Access Compliance Report

Public Rights-of-Way

(Curb Ramps)

Intersection ID: 43227	Main Street: N I-77_EXIT_5_RA	Cross Street: N I-77_HY	Location: NE
ADA ID: 1A00F0BFD95D	Ramp Type: Perp	Initial Pass/Fail: Fail	Overall Compliance: No
Severity Score: 8.75			
Codes/Mitigation Info/Possible Solution		Field Measurements/Component Compliance

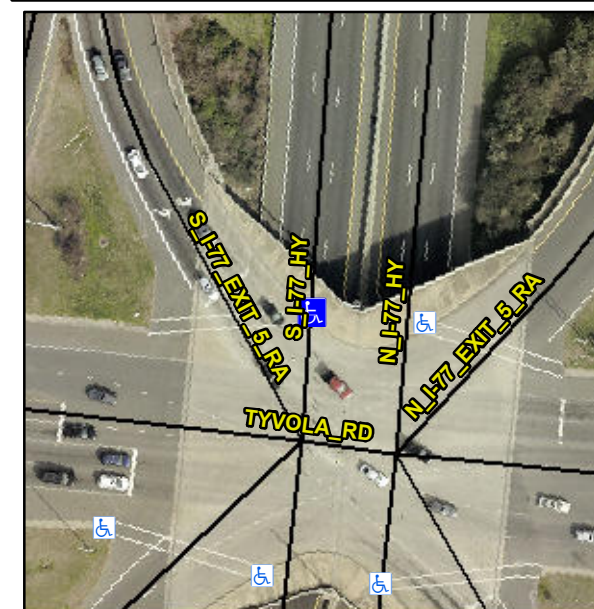
Not Found, R304.5.1

Compliance	Description	Data	Compliance	Description	Data
N/A	Ramp Length (in)	96.0	Yes	Ramp Slope (%)	7.1
No	Ramp Width (in)	39.0	Yes	Ramp XSlope (%)	1.7
N/A	Flare Type LT	N/A	N/A	Flare Type RT	N/A
N/A	Flare Slope LT (%)	N/A	N/A	Flare Slope RT (%)	N/A
N/A	Flare Traversable LT?	N/A	N/A	Flare Traversable RT?	N/A
N/A	Landing Length (in)	N/A	N/A	DWS Provided?	N/A
N/A	Landing Width (in)	N/A	N/A	DWS Contrast?	N/A
N/A	Landing Slope (%)	N/A	N/A	DWS Length (in)	N/A
N/A	Landing X Slope (%)	N/A	N/A	DWS Full Width?	N/A
N/A	Landing Curb? (Y/N)	N/A	N/A	DWS Offset (in)	N/A
N/A	Shared Landing?	N/A			
N/A	Gutter Ponding?	N/A	N/A	Gutter Slope (%)	N/A
N/A	Gutter Lip Ht (in)	N/A	N/A	Gutter X Slope (%)	N/A
N/A	Painted X Walk1?	Yes	N/A	Painted X Walk2?	N/A
	X Walk 1 Direction	To W		X Walk 2 Direction	N/A
N/A	X Walk 1 Width (in)	84.0	N/A	X Walk 2 Width (in)	N/A
	X Walk 1 Slope (%)	2.5		X Walk 2 Slope (%)	N/A
	X Walk 1 X Slope (%)	1.0		X Walk 2 X Slope (%)	N/A

Remove & Replace Entire Ramp.
